SERVICE LETTER

No. 666

Propeller Governor Speed-Adjusting Shaft, Lever and Lever Clamp Screw Replacement -- reference attached Woodward Service Bulletin No. 33549, dated May 1973.

Propeller governor speed-adjusting shaft, lever and lever clamp screw replacement.

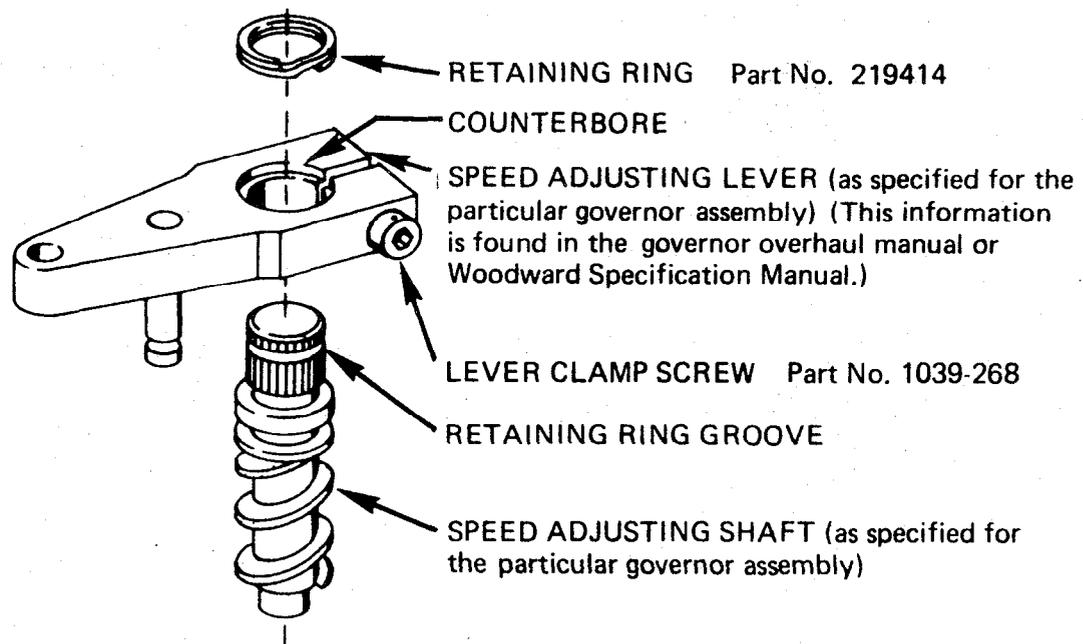
1. Apply an axial load of 5-10 pounds (in both directions) to the speed adjusting lever to determine that it is tightly clamped on the serrated shaft. Do not mistake end play of the shaft in the governor cover for a loose lever.

2. If the speed adjusting lever slides on the serrated shaft as the axial load is applied, the shaft and lever must be inspected to insure they are not excessively worn. Do not lose the radial relation between the shaft and lever. A new socket head screw, Part Number 1039-268 may be installed in place of the fillister head, lever clamp screw, to facilitate tightening. If they are in satisfactory condition, torque the clamp screw to 33-38 lb. ins. with the lever at the maximum rpm setting and positioned axially on the shaft to maintain .020-.045 inch clearance between the bottom side of the lever and the top of the governor cover. Recheck per paragraph 1 above, and, if secure, lockwire the clamp screw.

3. If 33-38 lb. ins. torque applied to the lever clamp screw does not secure the lever on its shaft, the lever or shaft is worn excessively and is unserviceable.

Return the governor to Woodward Governor Co. or an FAA approved governor overhaul station for corrective action or replace it with a serviceable exchange unit.

4. At next regular governor overhaul, if not already incorporated, install the following new parts to provide positive lever retention.

1. Speed adjusting shaft with retaining ring groove.
2. Speed adjusting lever with counterbore.
3. Retaining ring.
4. Lever clamp screw (installed torque of 33-38 lb. ins. is required).
